# UNITED STATES PATENT AND TRADEMARK OFFICE

APPLICATION NO.	FILING DATE	FIRST NAMED INVENTOR	ATTORNEY DOCKET NO.	CONFIRMATION NO.
10/715,703	11/18/2003	Peter Tiesler	ZAHFRI P574US	5406

<b>Office Action Summary</b>	<b>Application No.</b> 10/715,703	<b>Applicant(s)</b> TIESLER ET AL.	
	<b>Examiner</b> Rodney H. Bonck	<b>Art Unit</b> 3681

### DETAILED ACTION

# Annotated Marked-Up Drawing

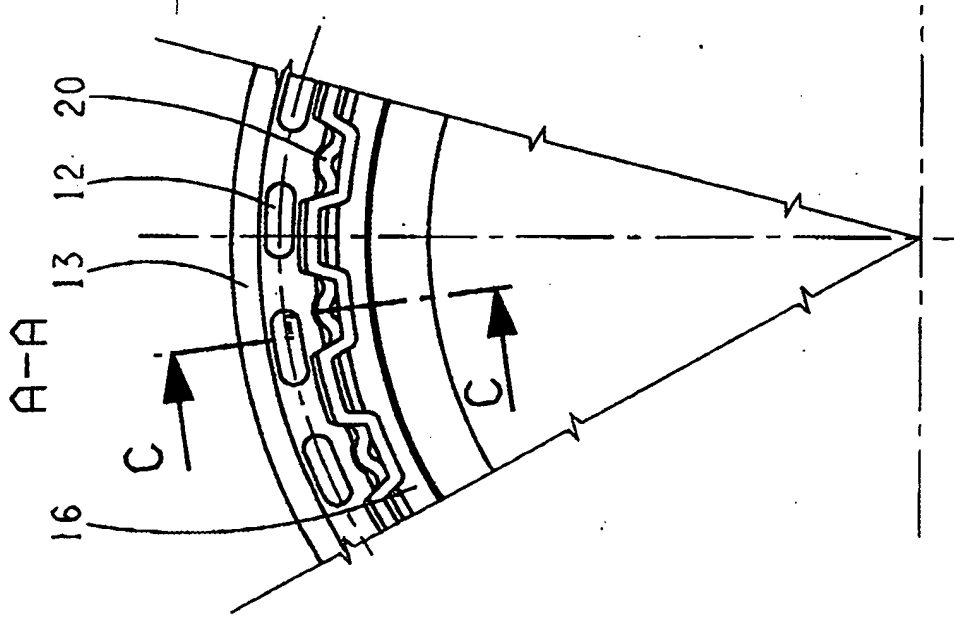
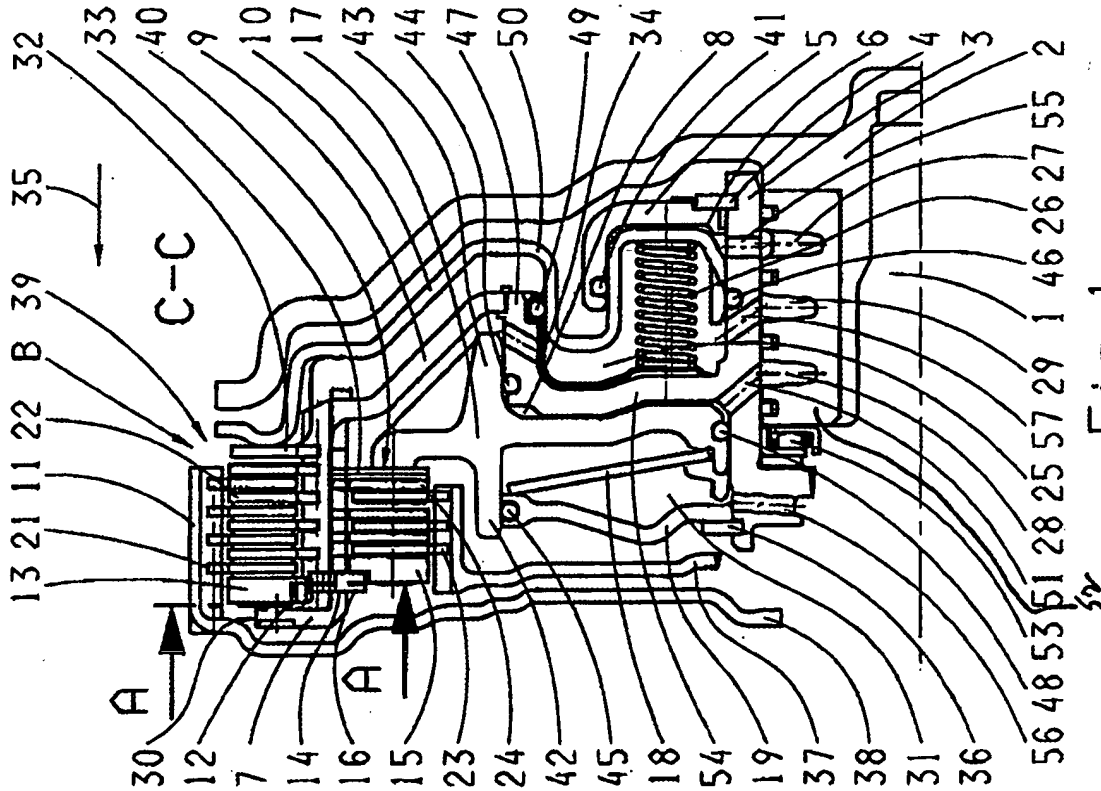
Receipt is acknowledged proposed drawing change filed May 5, 2005. The proposed change is approved. Corrected drawings should have been submitted in response to the previous Office action. The objection is repeated below:

The drawings are objected to as failing to comply with 37 CFR 1.84(p)(5) because they do not include the following reference sign(s) mentioned in the description: **52. Corrected drawing sheets in compliance with 37 CFR 1.121(d) are required in reply to the Office action to avoid abandonment of the application.** Any amended replacement drawing sheet should include all of the figures appearing on the immediate prior version of the sheet, even if only one figure is being amended. The replacement sheet(s) should be labeled "Replacement Sheet" in the page header (as per 37 CFR 1.84(c)) so as not to obstruct any portion of the drawing figures. If the changes are not accepted by the examiner, the applicant will be notified and informed of any required corrective action in the next Office action. The objection to the drawings will not be held in abeyance.

Approved  
06/21/05
